IDA PAPER P-3016

**INDEPENDENT REVIEW OF THE DEVELOPMENT
RISKS ASSOCIATED WITH THE COMANCHE
ARMED RECONNAISSANCE HELICOPTER**

August 1994

Prepared for
Director, Tactical Warfare Programs

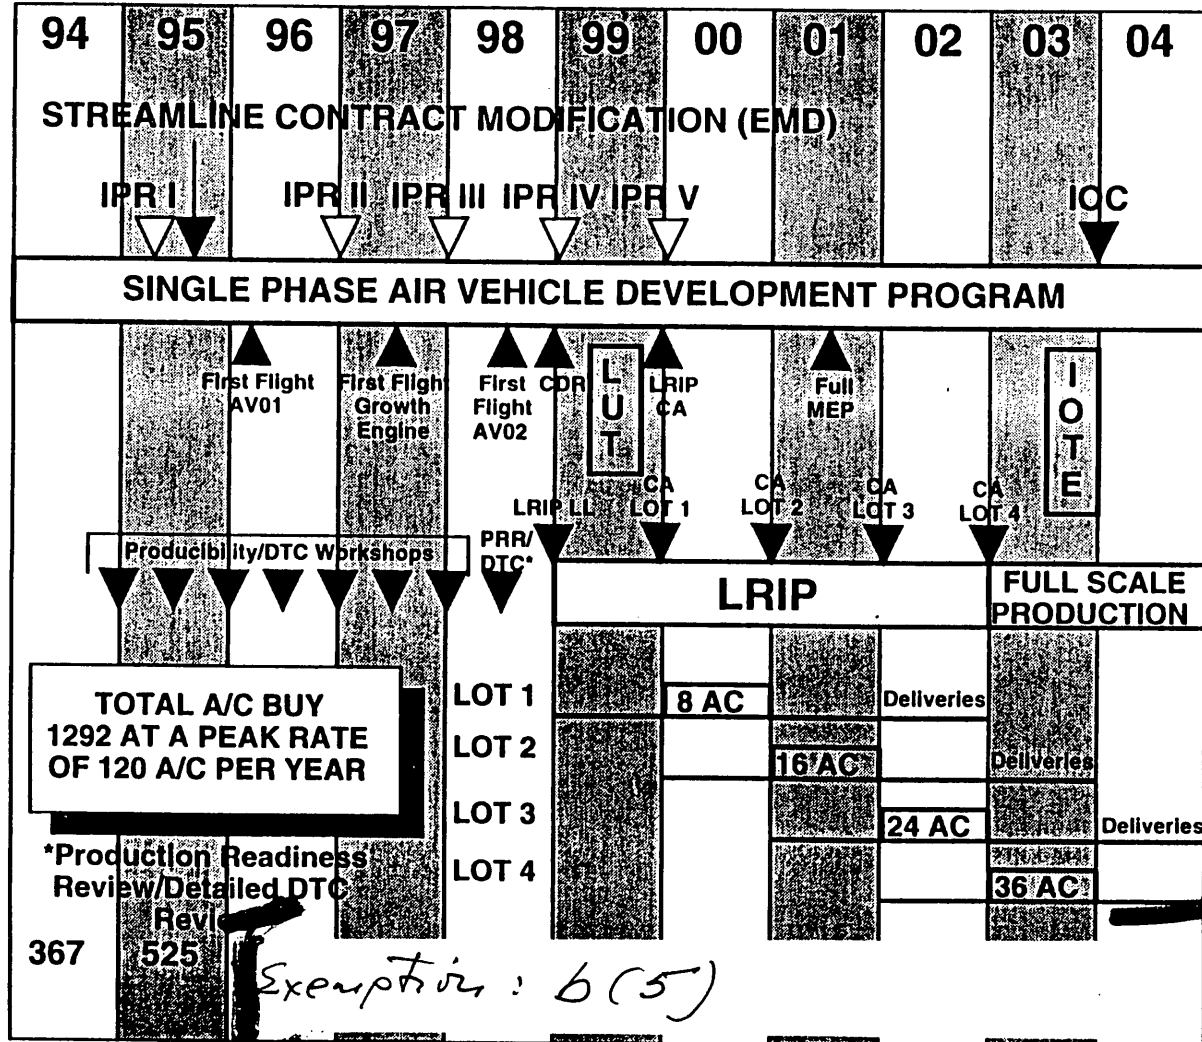
The schedule for the "streamlined" development program proposed by the Army is shown on this chart. Under this plan, in May 1995 the Army would modify the existing COMANCHE development contract to incorporate the activities normally conducted during EMD into a new single-phase development program. The first flight of the first of two DEM/VAL prototypes would occur in early FY 1996, several months later than was proposed under the existing development contract. The first flight of the second DEM/VAL prototype would not occur until late FY 1998, nearly 2 1/2 years after the first flight of the first prototype. The next three prototypes would be taken from the first lot of eight Low-Rate Initial Production (LRIP) aircraft. These prototypes would be delivered to the Army during FY 2002.

In comparison to the Army's previous plan for COMANCHE development, the "streamlined" plan initiates production one year earlier, but at a significantly slower rate. In the first year (FY 2000), only 8 aircraft would be built; in the second, 16 aircraft; in the third, 24 aircraft; and in the fourth (FY 2003), 36 aircraft.

OSD oversight for this program would be accomplished through a series of In-Process Reviews (IPRs), the first of which would occur early in FY 1995 prior to the award of the modified development contract. Beginning at the end of FY 1996, in-process reviews would

Finally, as indicated on the chart, the funding profile for the proposed "streamlined" program is the same as is currently planned for the existing program.
